Subject: Response to Petition for Fuel Leak Case No. RO0000458 and GeoTracker Global ID T0600100262, Glovatorium, 3820 Manila Avenue, Oakland, CA 94611

This correspondence presents the Alameda County Environmental Health (ACEH) response to the November 18, 2011, "*Petition for UST Case Closure for the Former Underground Storage Tank Area (i.e. the Glovatorium) Located at 3820 Manila Ave., Oakland, CA 94611,*" (Petition). The Petition, which was submitted to the State Water Resources Control Board (SWRCB) by Franklin J. Goldman, is dated November 18, 2011. The Petition requests that the SWRCB review the case and facilitate regulatory closure of the case. The Responses to Petition below describe the major reasons that this case should not be closed at this time.

Figure 12
Free Product Thickness
Former Glovatorium Site
3820 Manila Avenue, Oakland, California

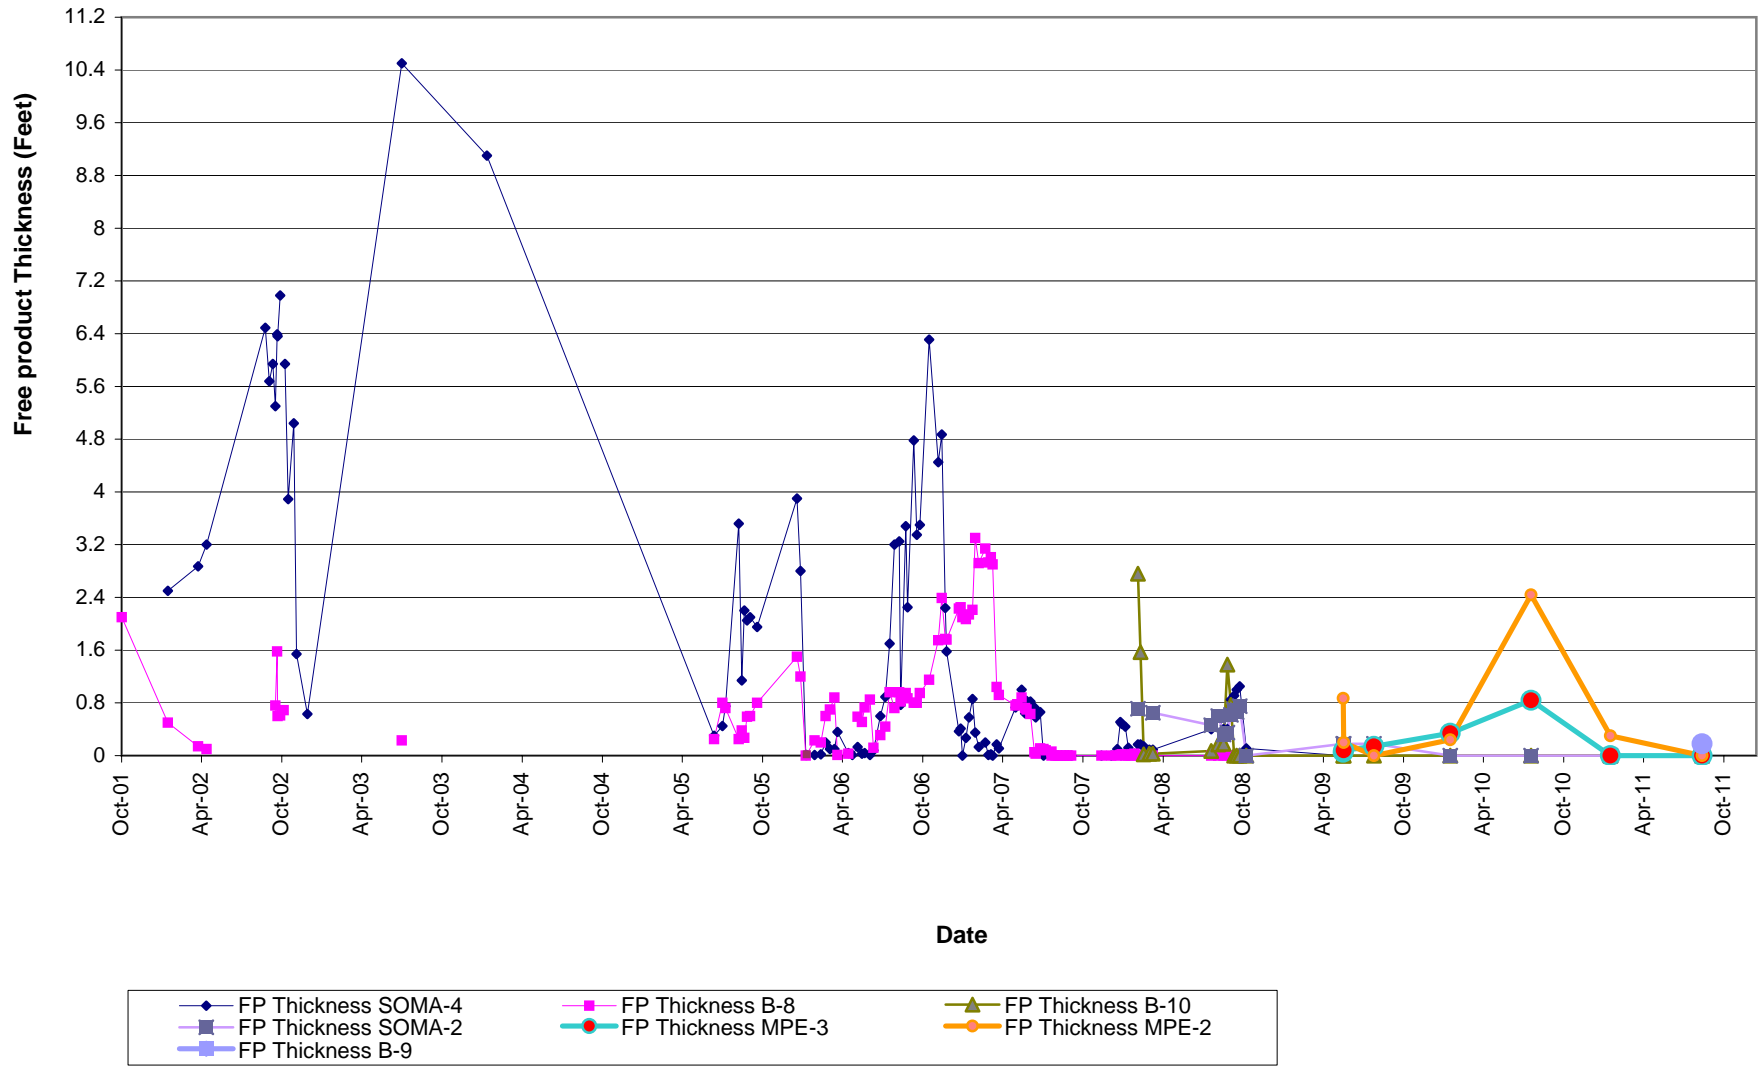
- 1. Free Product Delineation and Potential for Vapor Intrusion to Off-Site Building.** Free product has been observed historically in several wells and was observed in wells MPE-2 and MPE-3 during groundwater sampling events in February and August 2010. The thickness of free product in well MPE-3 increased from 0.34 feet in February 2010 to 0.84 feet in August 2010. The thickness of free product in well MPE-2 increased from 0.24 feet in February 2010 to 2.44 feet in August 2010. Well MPE-3 is located near the northeastern site boundary immediately adjacent to the Red Cross building. The extent of free product to the north and east is unknown. In order to assess whether the free product observed in the northeastern portion of the site could pose a potential risk for vapor intrusion to indoor air, ACEH also requested plans to collect and analyze one or more soil vapor samples in the northeastern portion of the site. Of particular concern is the potential for chlorinated solvents to volatilize from the free product to soil vapor beneath off-site buildings. Based on information regarding the construction of the Red Cross building foundation, ACEH has deferred decisions on the scope of work needed to evaluate the potential for vapor intrusion until free product

delineation has been completed. To date, the extent of free product in the area of the adjacent Red Cross Building has not been evaluated.

BORING NO. **B11**

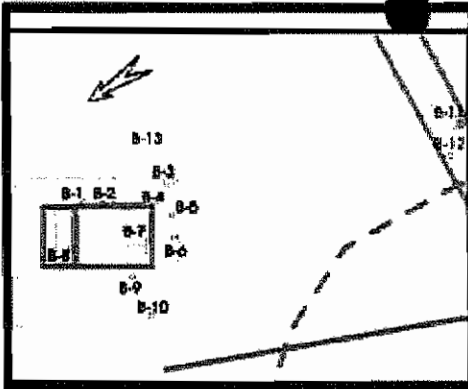
*double-cased
the whole
way?*

not analyzed

logs indicate sample analyzed

Graph of Decreasing dissolved PCE in ground water at LFR-3 Located at the Former Glovatorium / Depper UST Investigation Area at 3820 Manlia Ave., Oakland, California

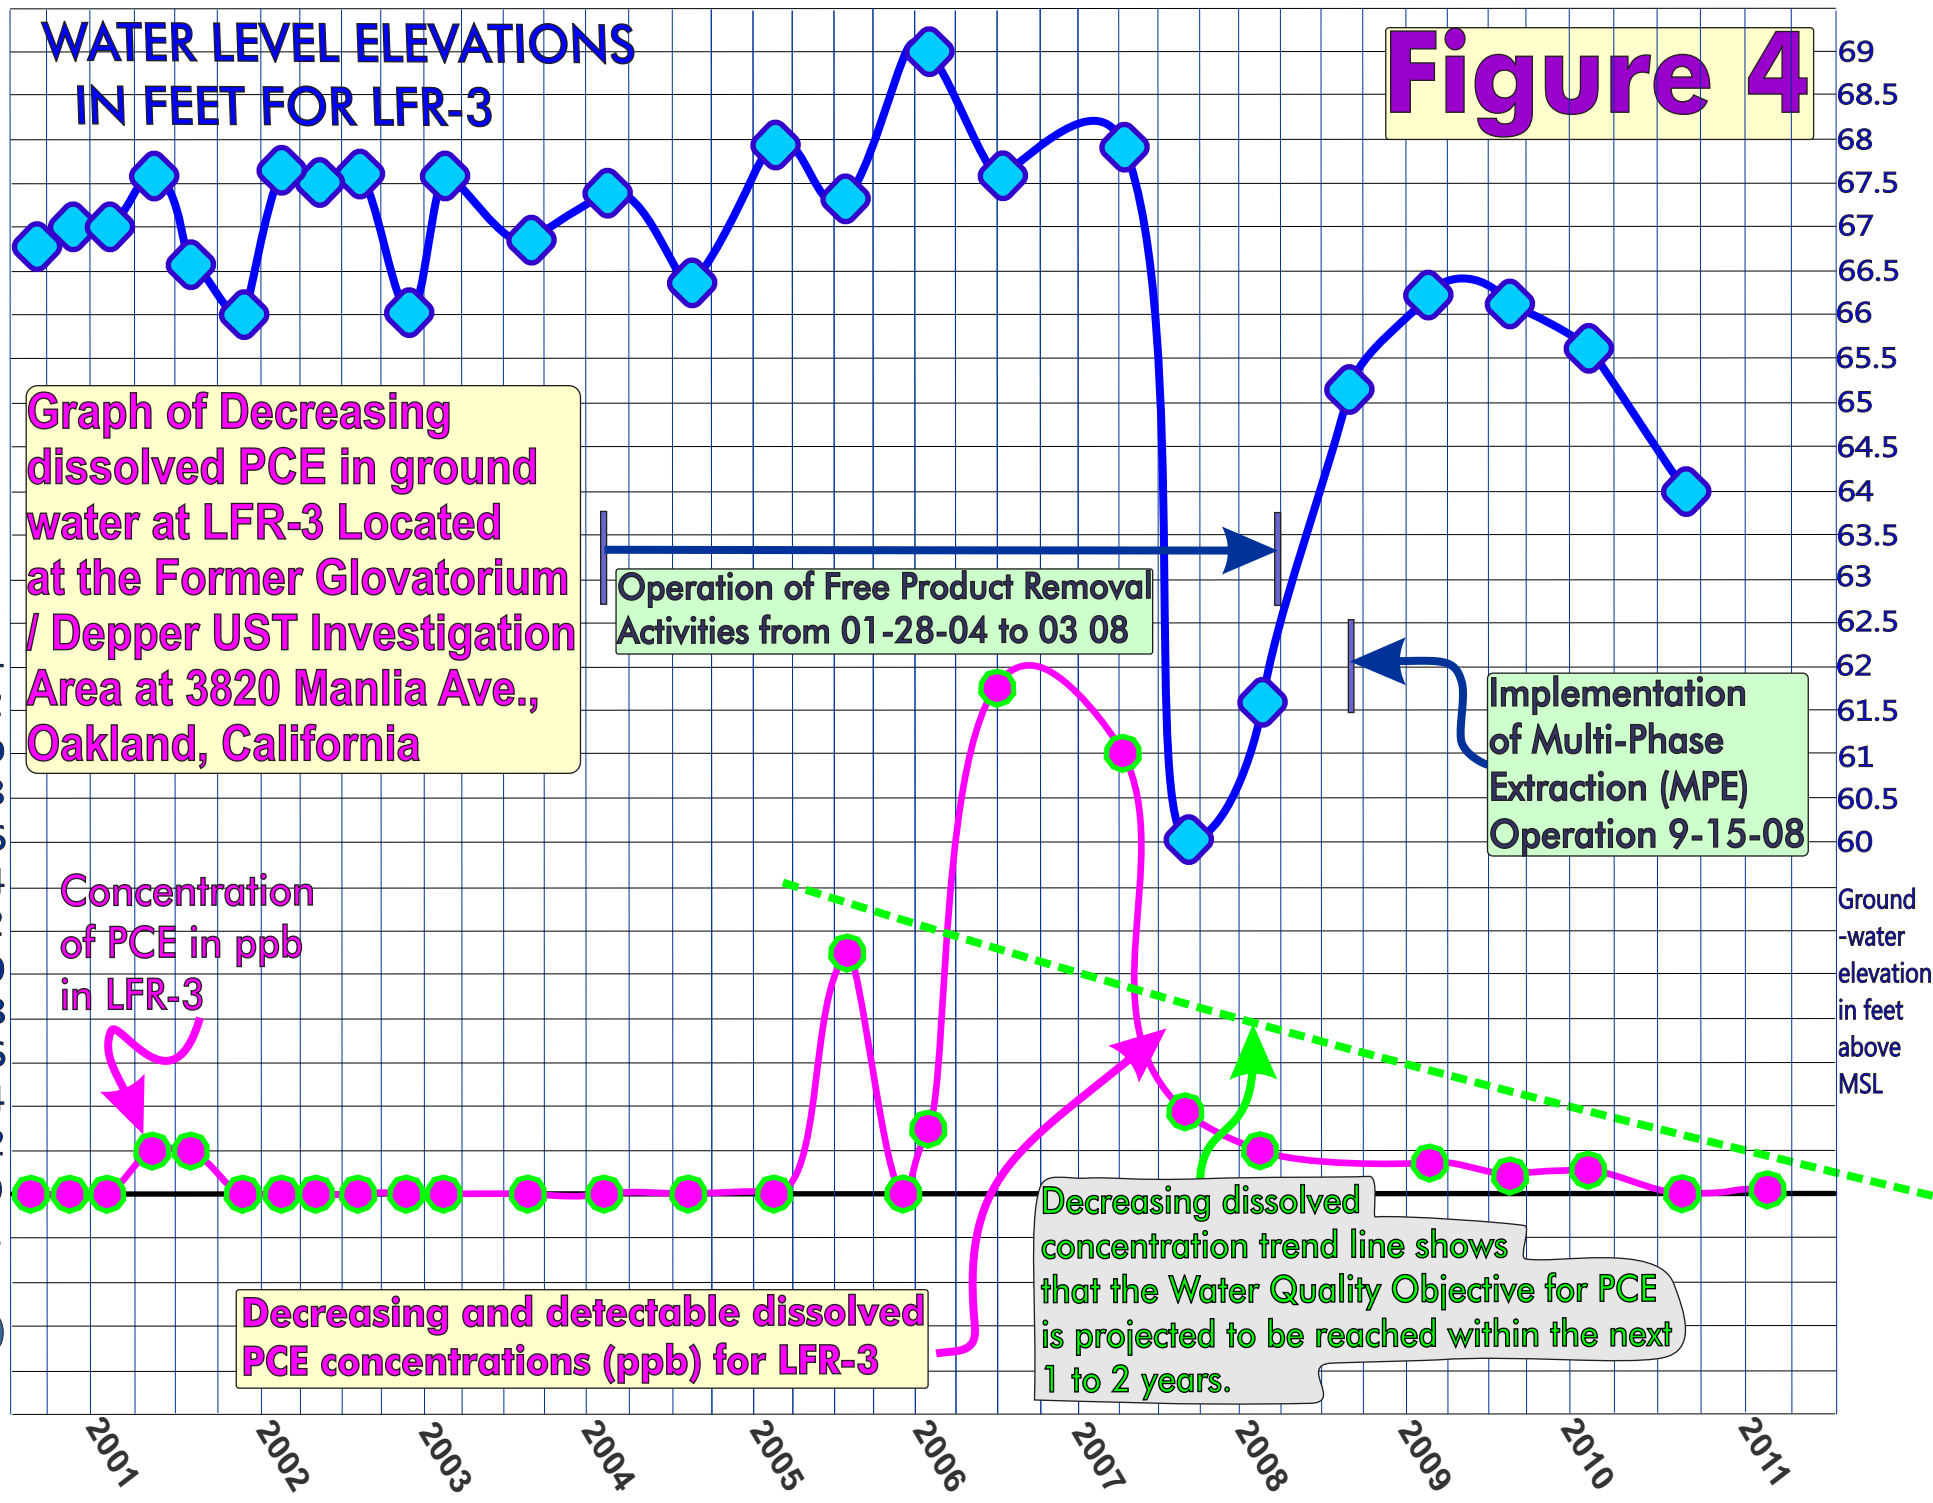
6. **Groundwater Concentration Graphs.** The Petition presents concentration graphs for PCE in groundwater using data from four monitoring wells. In each case, the graph shows a declining trend line with a projection that water quality objectives will be achieved within less than two to six years. The starting points for each of the trend lines appear to have been arbitrarily chosen with higher concentrations in order to show a declining trend (Attachment 5). In addition, some of the graphs plot elevated reporting limits as higher concentrations on the graph. The trend lines are then drawn downward from the high reporting limits to artificially show a declining trend line. These highly questionable trend lines are then extended to "predict" when water quality objectives will be achieved. For two of the wells, water quality objectives appear to have already been achieved but the graph forces a trend line to "predict" when water quality objectives will be achieved. It is obvious that the trend lines shown on the concentration graphs are not valid and the "predictions" based on these trend lines are also not valid. Moreover, the depiction of declining PCE groundwater concentrations in the four wells selected in the Petition leaves out significant considerations regarding trends in groundwater quality for the site. Since February 2007, the concentration of TPH as Stoddard solvent in groundwater from well LFR-2, which is the monitoring well nearest to the residences, has increased from 1,200 to 470,000 micrograms per liter. Any assessment of water quality for the site must also consider the potential for rebound following the cessation of MPE and the generation of PCE daughter products such as vinyl chloride.
